Quality Assurance Section

Bicycle & Pedestrian Scoping Study *along Route 100 in Dover, VT*

Dover STP BP14(16)

DRAFT
Submitted to the
Town of Dover
Vermont

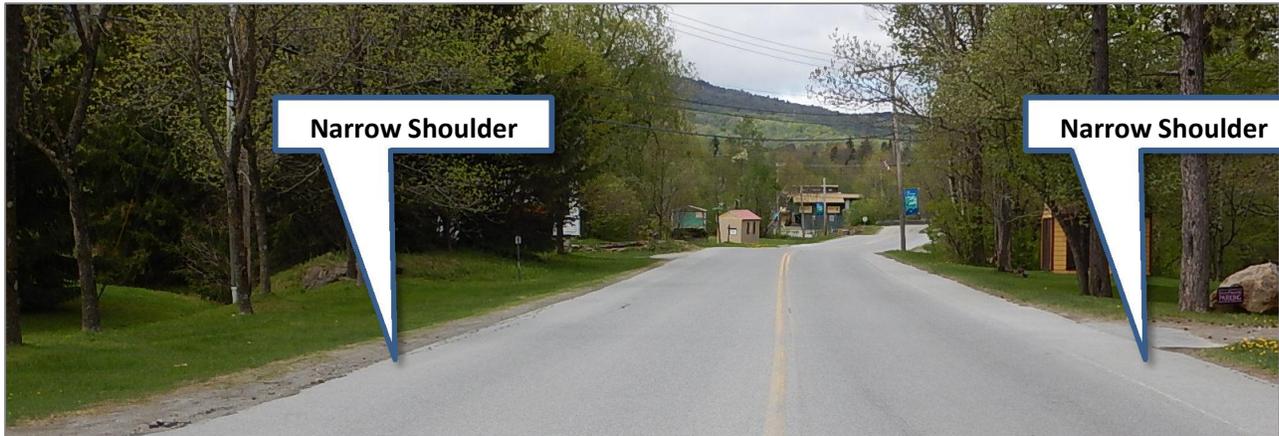
Please state what the actual paved shoulder width is; it looks like 3 to 4 feet below. Very generic argument, in my opinion.

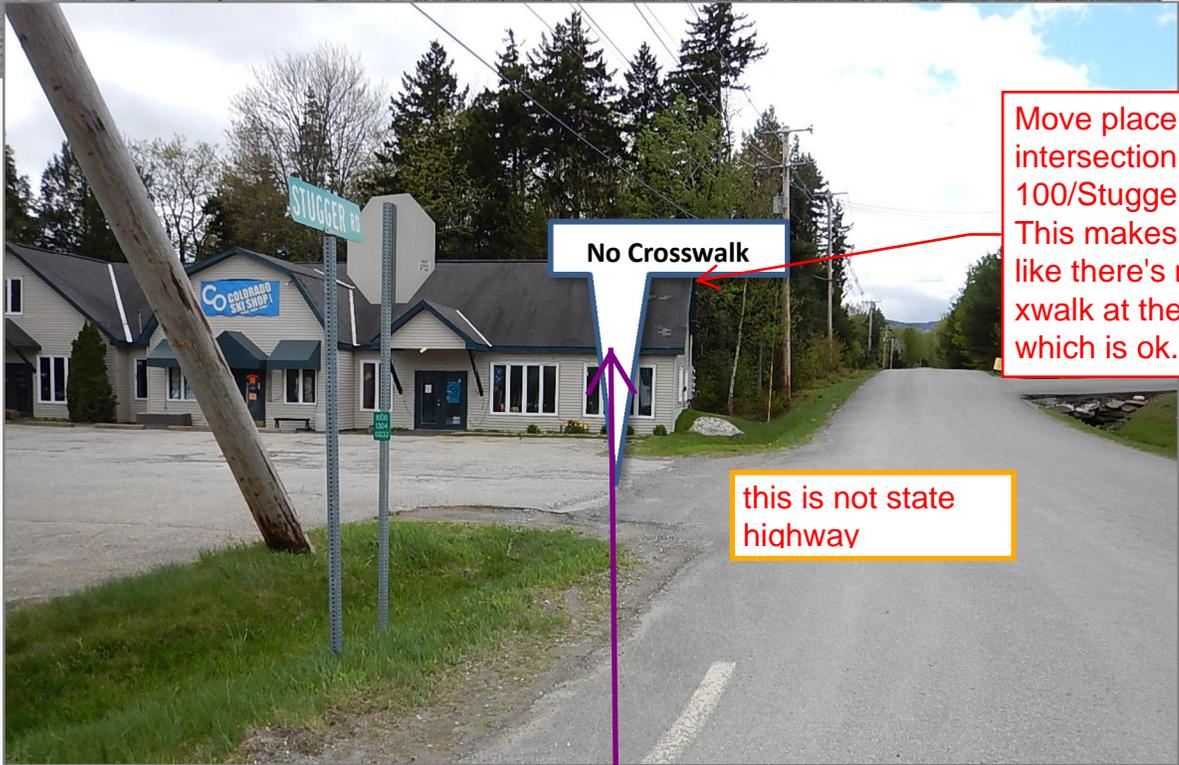
The posted speed limit through this area is 40-mph. Would crosswalk warrants be met at any of the desired

Painted crosswalk not required across the throat of a drive.

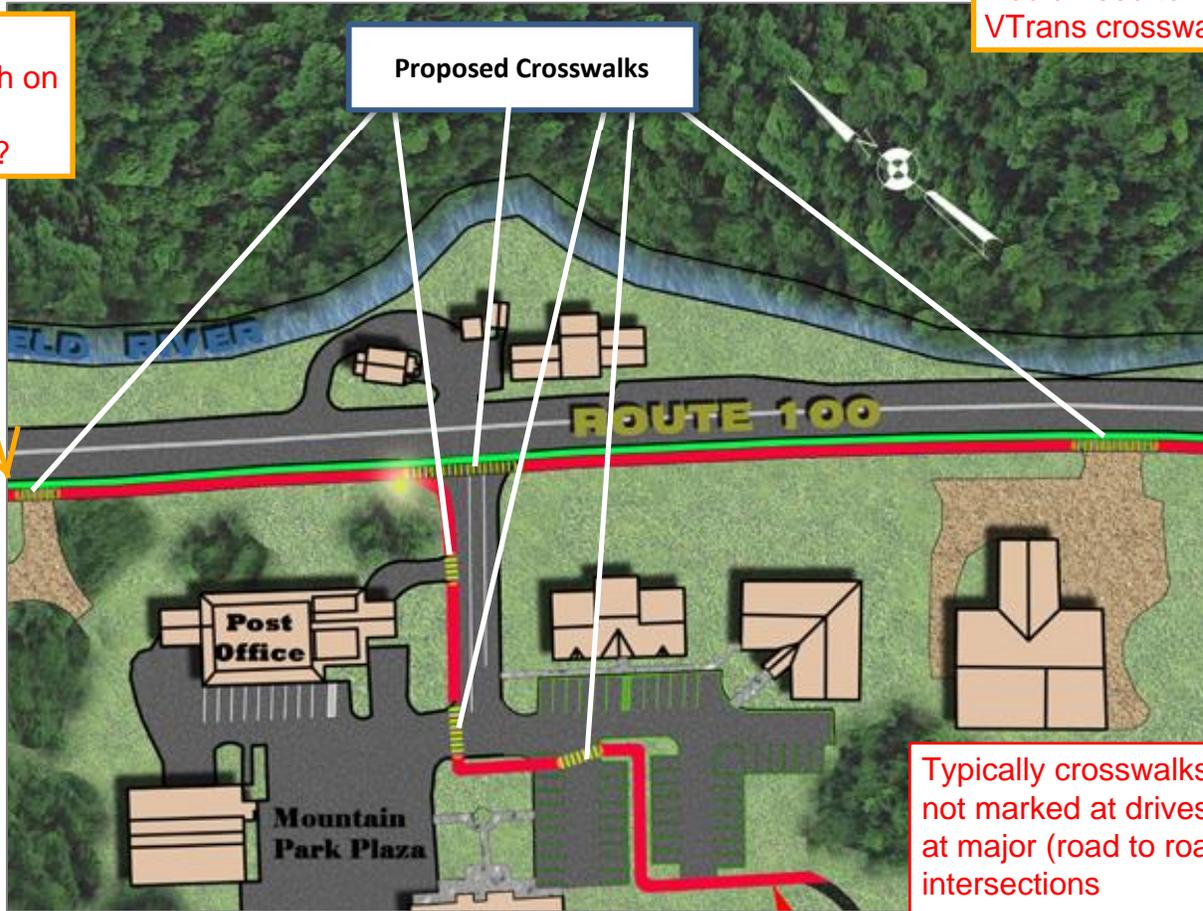
This sidewalk continues north on this side to Stugger Road?

Typically crosswalks are not marked at drives, only at major (road to road) intersections

Install Street Lighting at Intersections to Enhance Safety

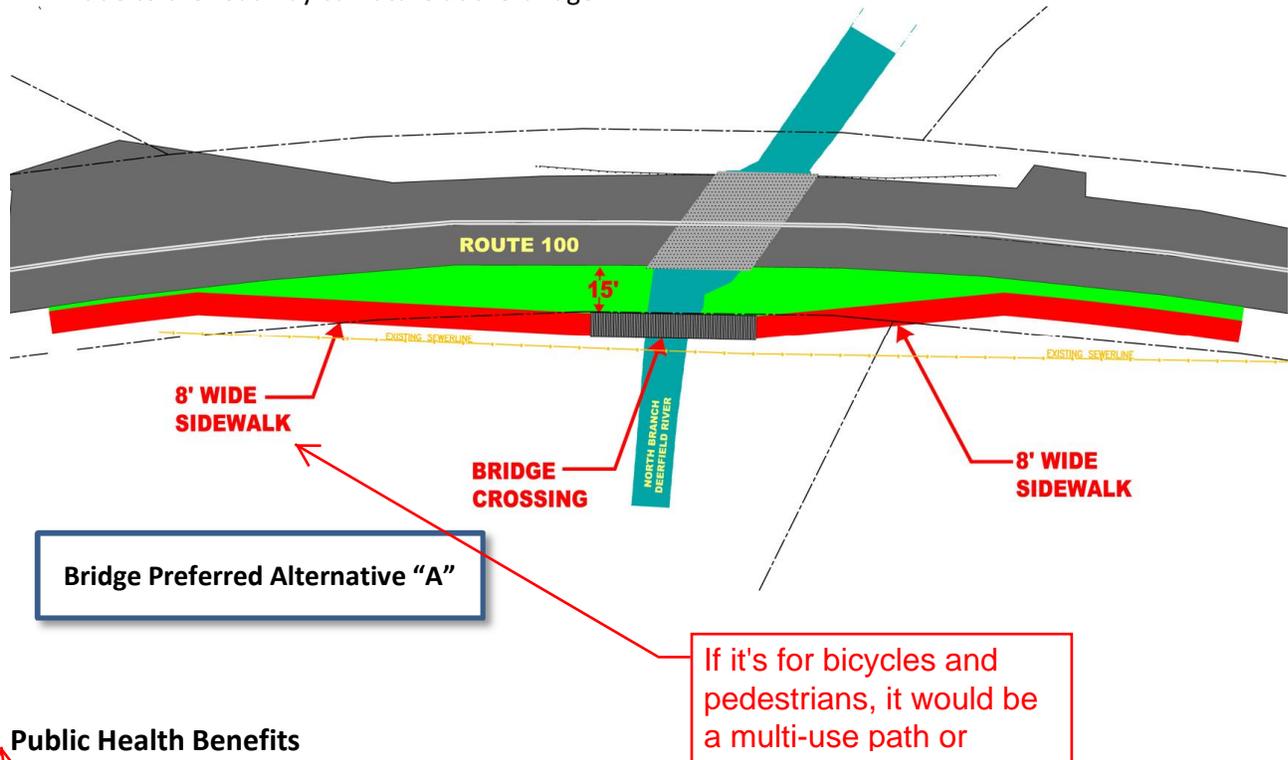
Is there that much anticipated foot traffic at night?

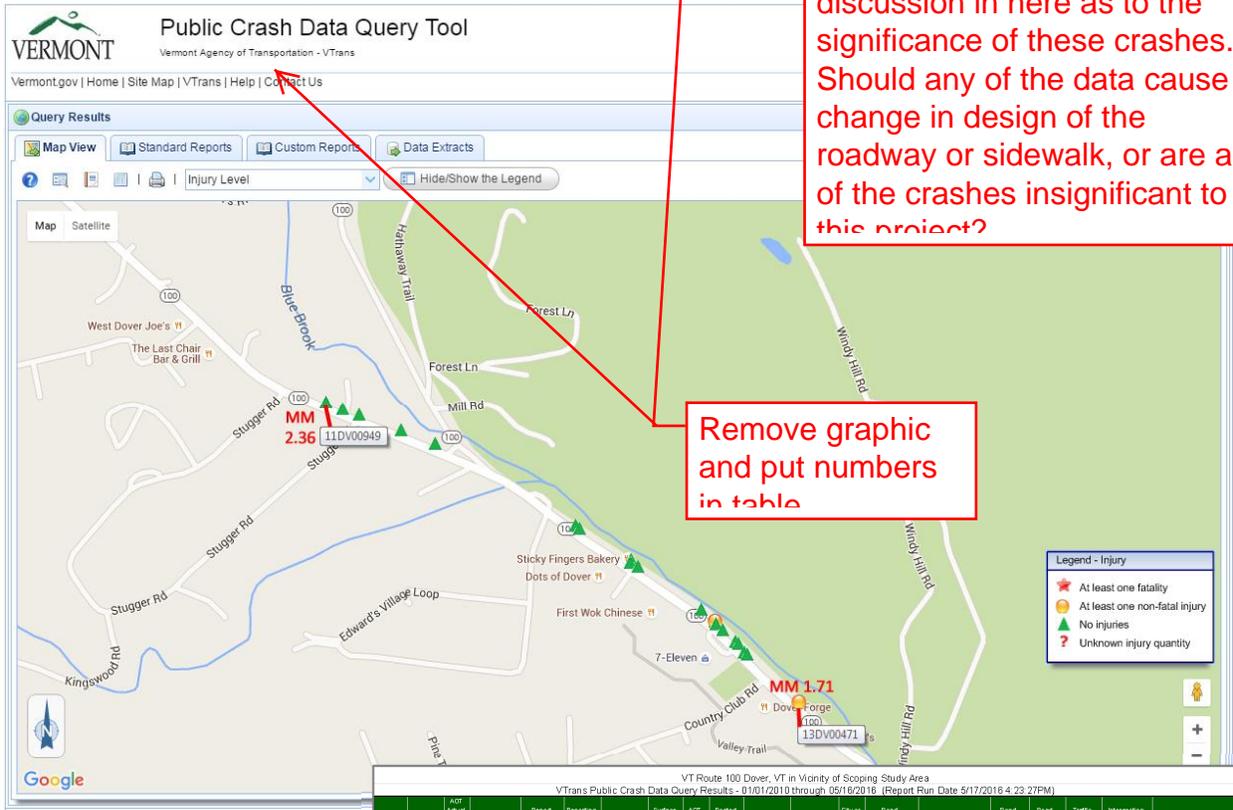
Remove graphic and put numbers in table

Alternative B

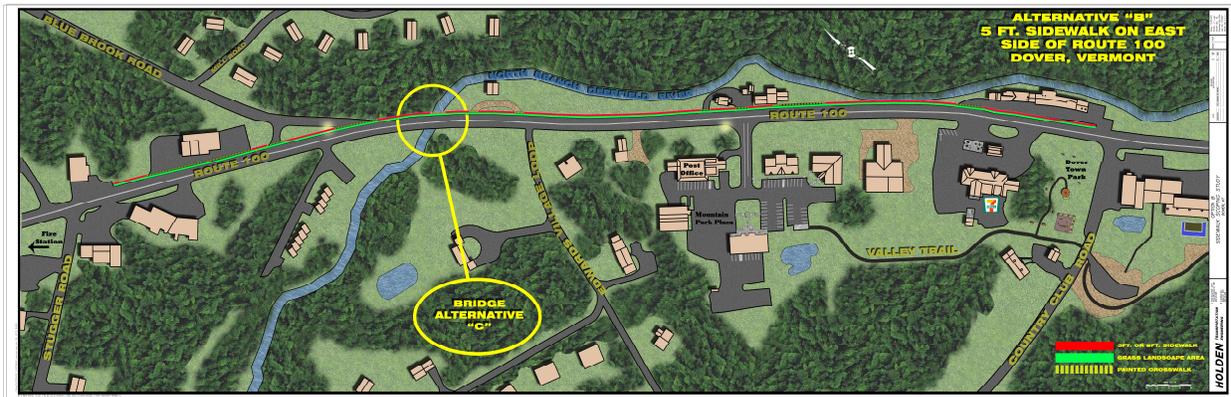
What about some discussion of using the road shoulders for bicycling with this alternative. Look to be fairly adequate shoulders.

Alt B. should include discussion of crossing VT 100 to get from the path to this walk

Bridge Alternative A – Preferred Alternative

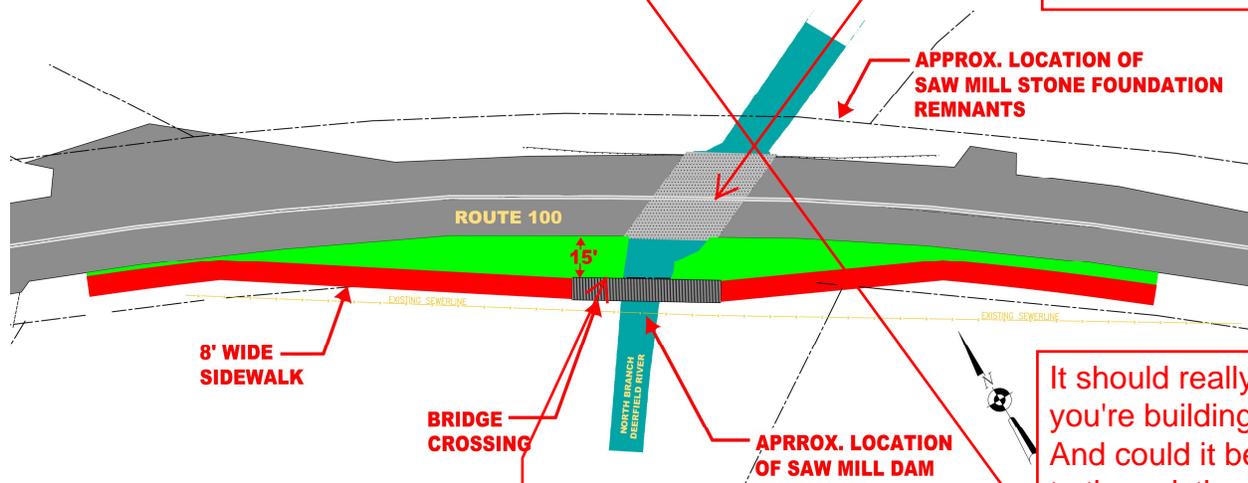
How old and what is the status of this bridge? Is it due for replacement? What does the inspection report

It should really be 10' if you're building a bridge. And could it be added to the existing structure? Or part of a replacement structure? I didn't see any

**HOUSE
 PREFERRED
 ALTERNATIVE
 "D"**

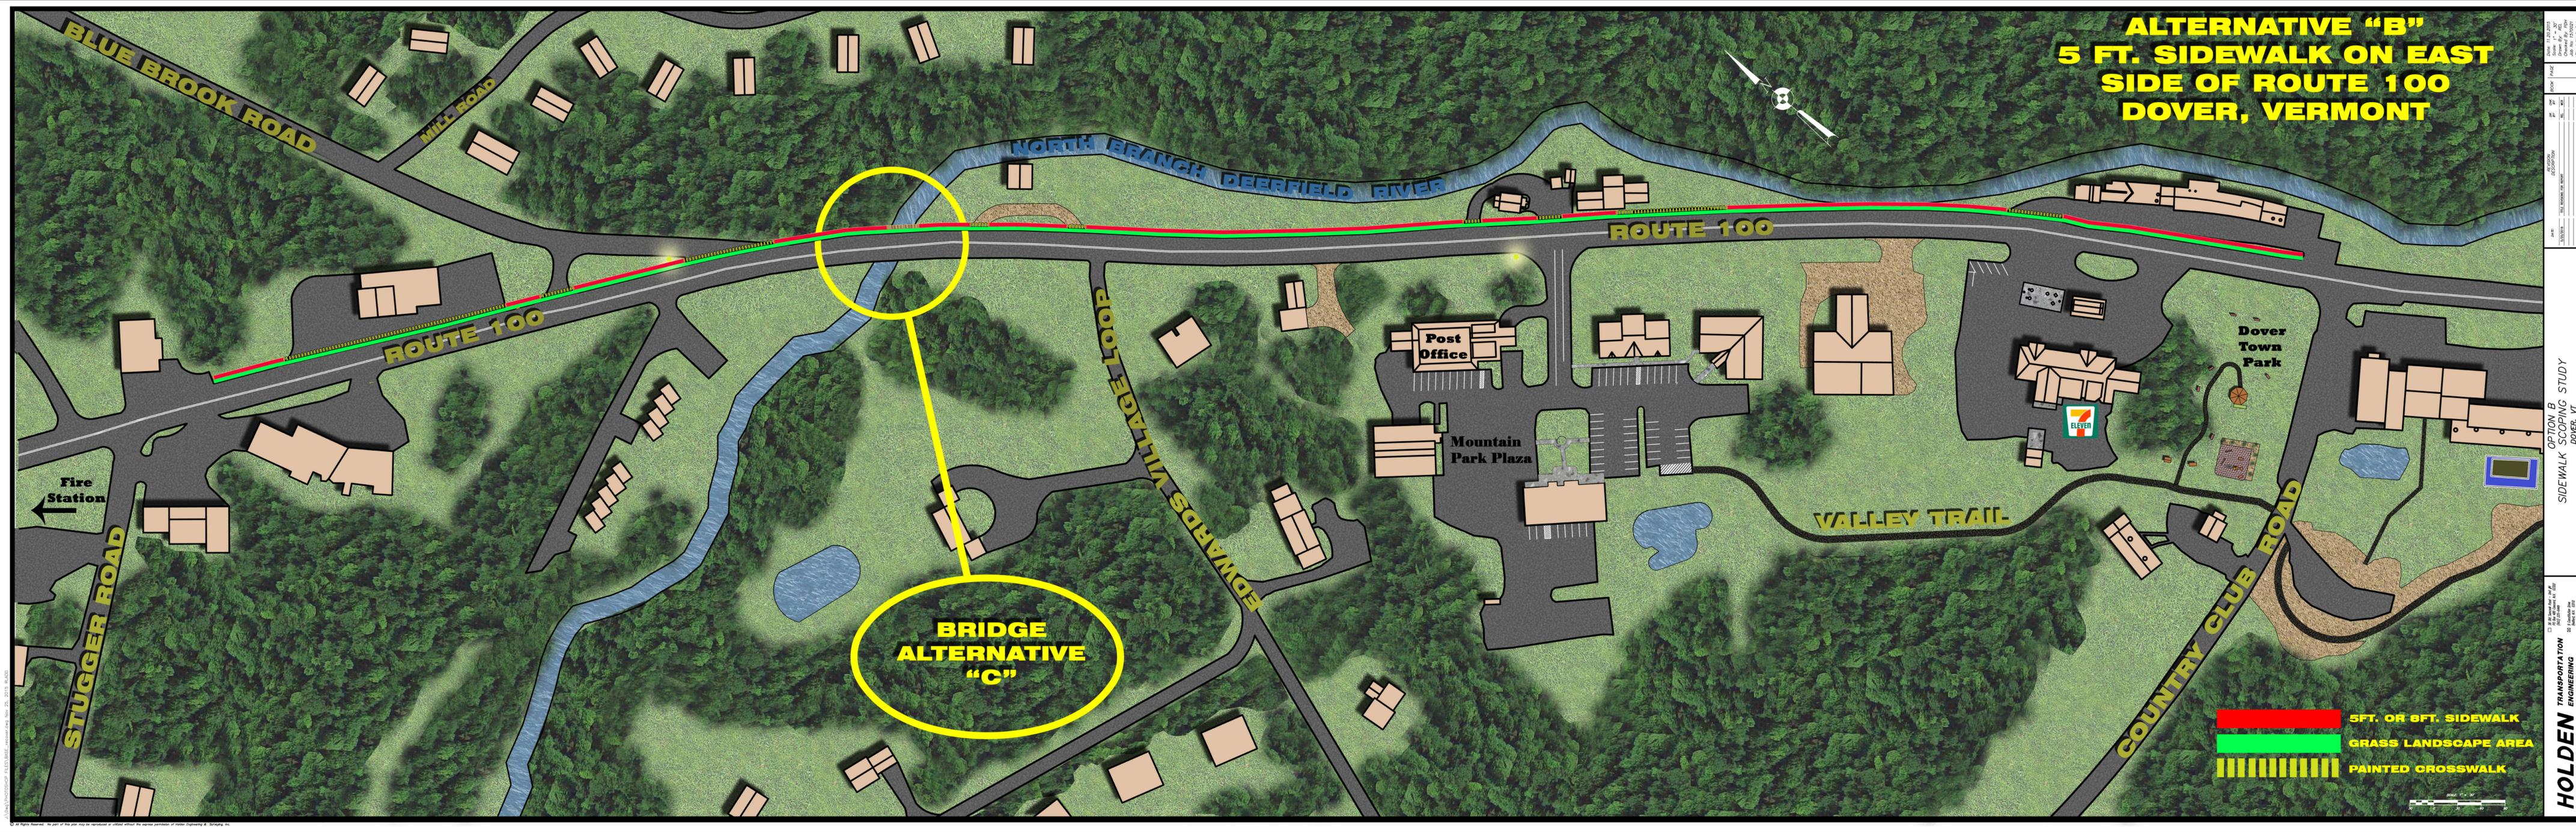
Not really a big deal, but you have grass running through roads and drives
